Bid #17-867T – Clarification #1

60 Compo Beach Road

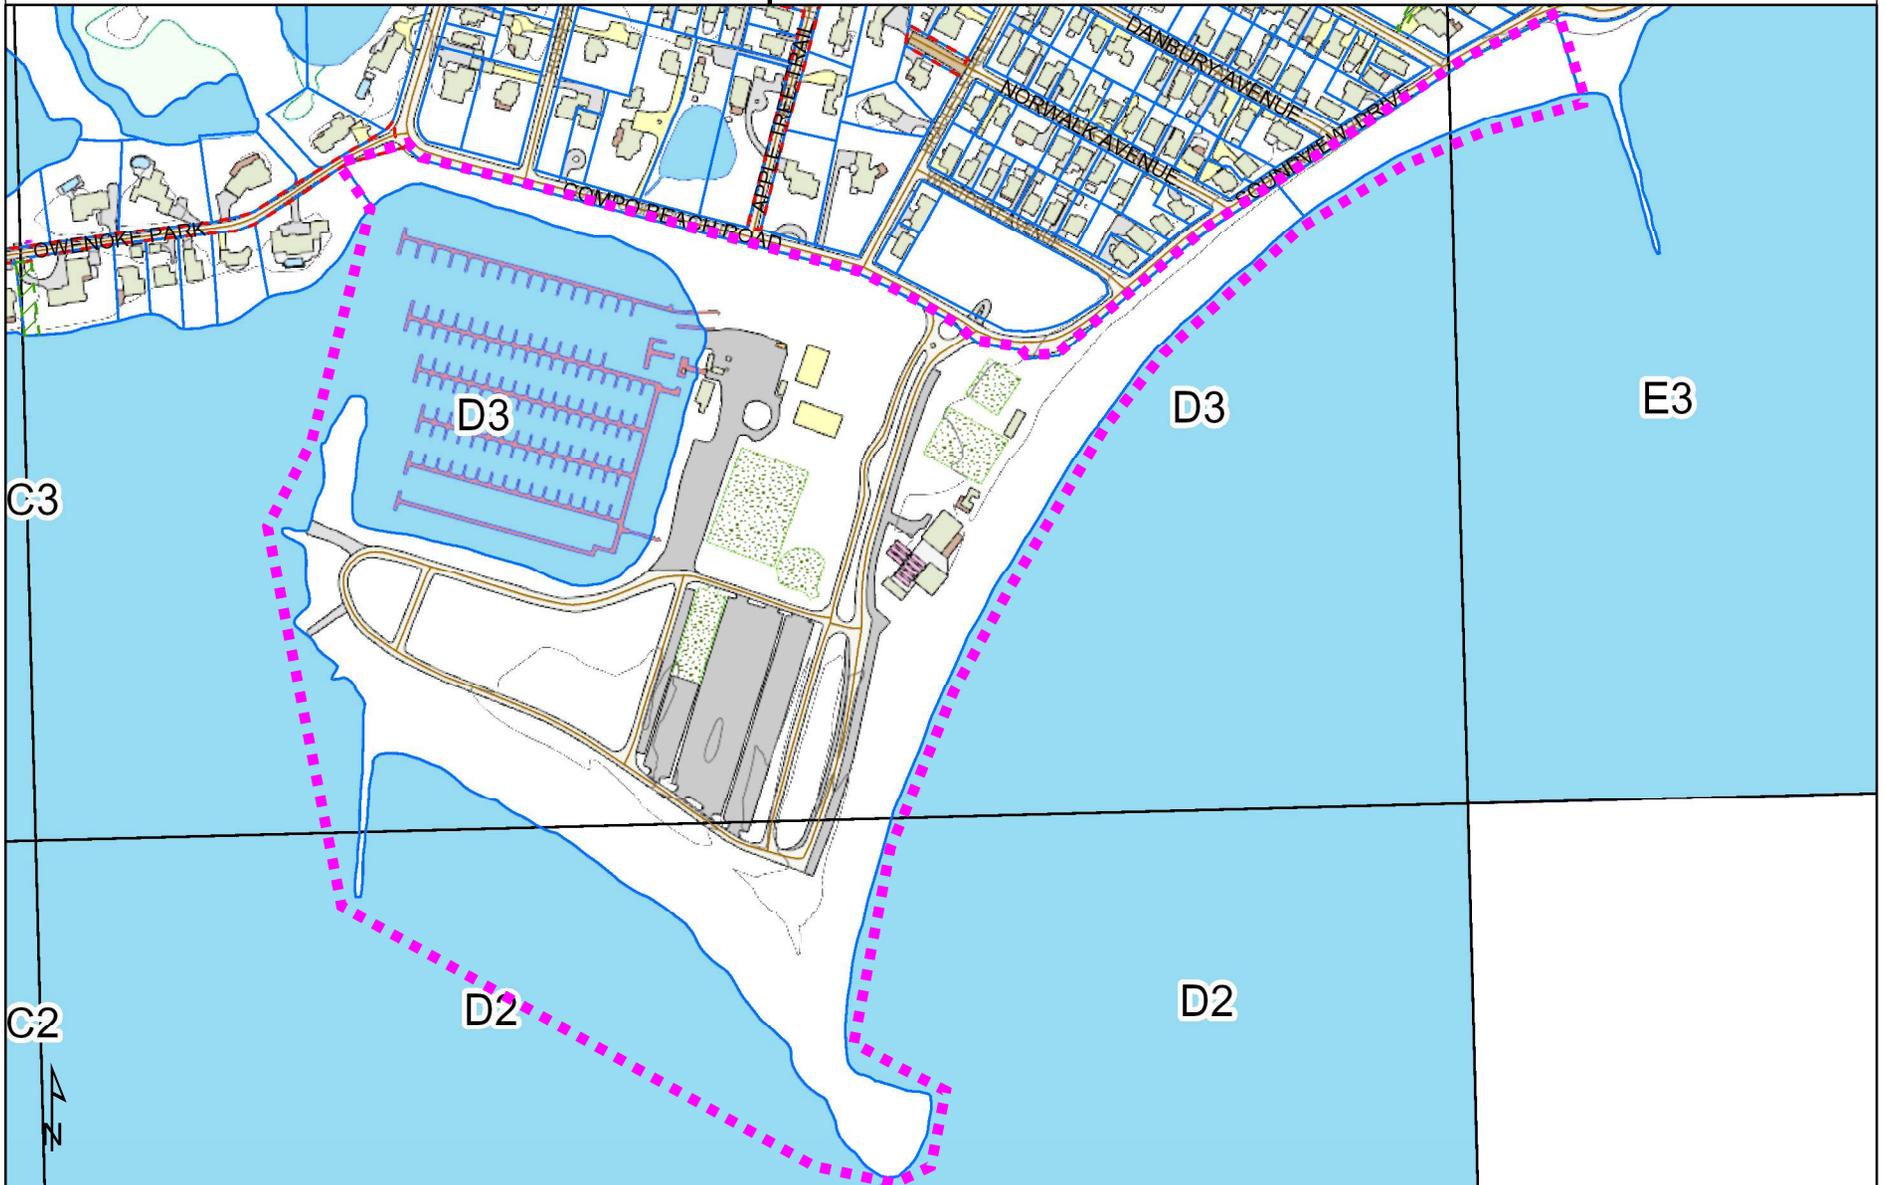
Q: Can you provide a sketch showing the limits of the area to be surveyed?

A: There is a sketch showing the approximate boundaries of the survey attached to this clarification. Of course the records search will determine the actual property limits.
